NOTICE TO ALL CONTRACTORS:

Proposal #01: 1070-04-64, WISC 2025568
La Crosse - Sparta
Black Rvr. Round Lk, Bainbridge Brg
IH 90
LA Crosse County

This is Addendum No. 01, which provides for the following:

Addendum No. 01
ID 1070-04-64
Added Sheet 8A
August 8, 2025

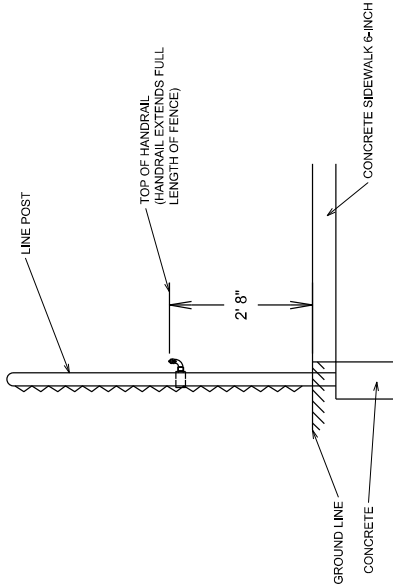
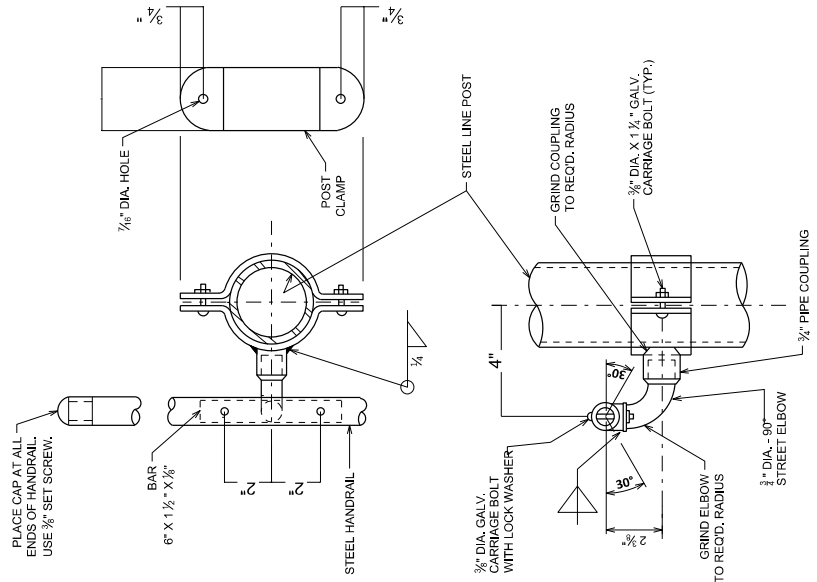
Added Plan Sheets	
Plan Sheet	Plan Sheet Title (brief description of why sheet was added)
8A	Added detail sheet for chain link fence handrail

CHAIN LINK FENCE HANDRAIL DETAILS

Addendum No. 01
ID 1070-04-64
Revised Sheet 39
August 8, 2025

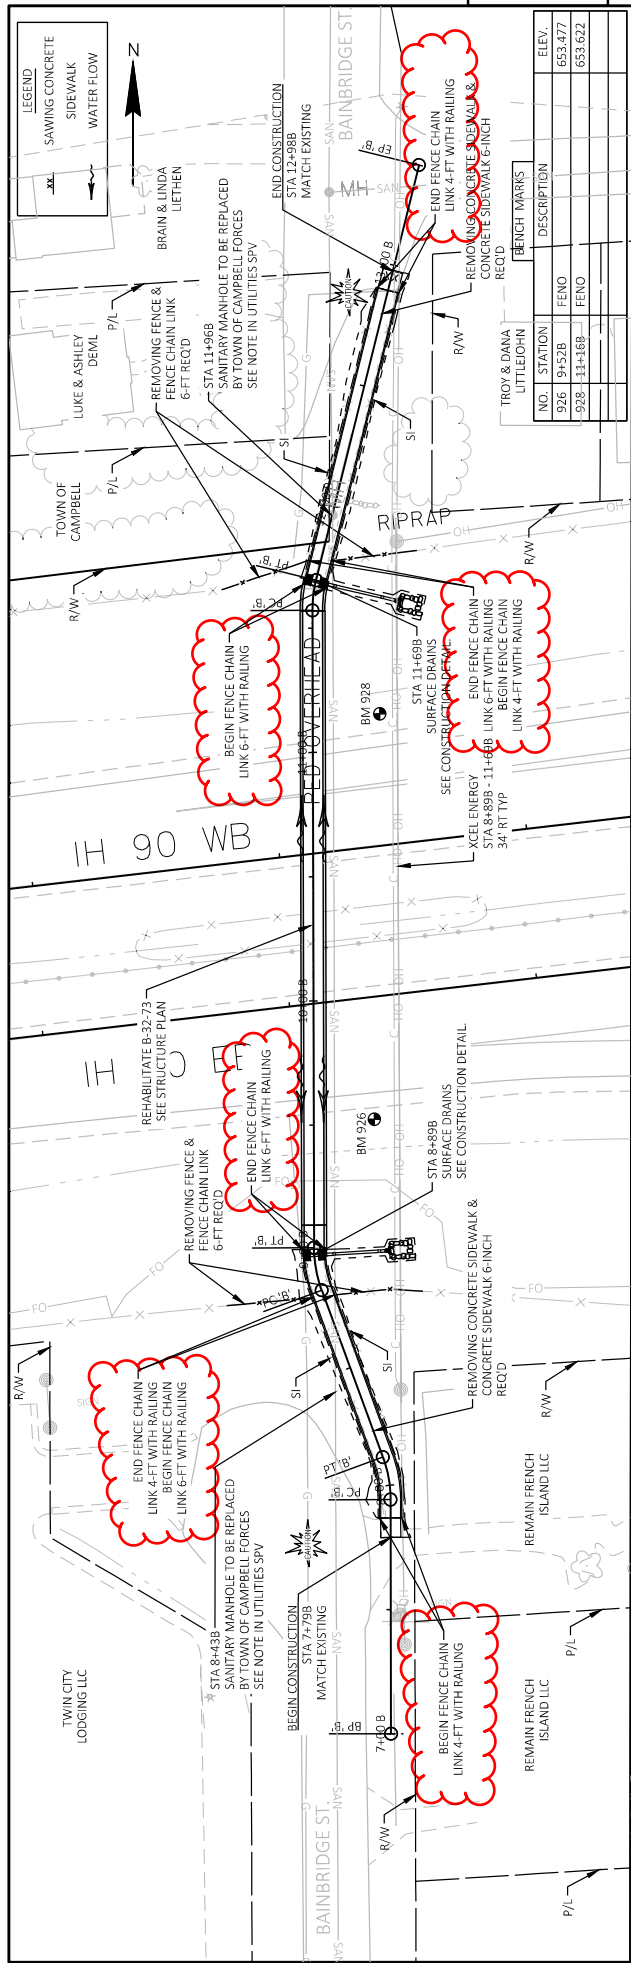
Revised Plan Sheets	
Plan Sheet	Plan Sheet Title (brief description of changes to sheet)
39	Miscellaneous Quantities (Item change 513.8011 to SPV.0090.03/04)
41	Miscellaneous Quantities (Added Item 643.1205.S)
45	Plan sheet (changed fence type and locations)
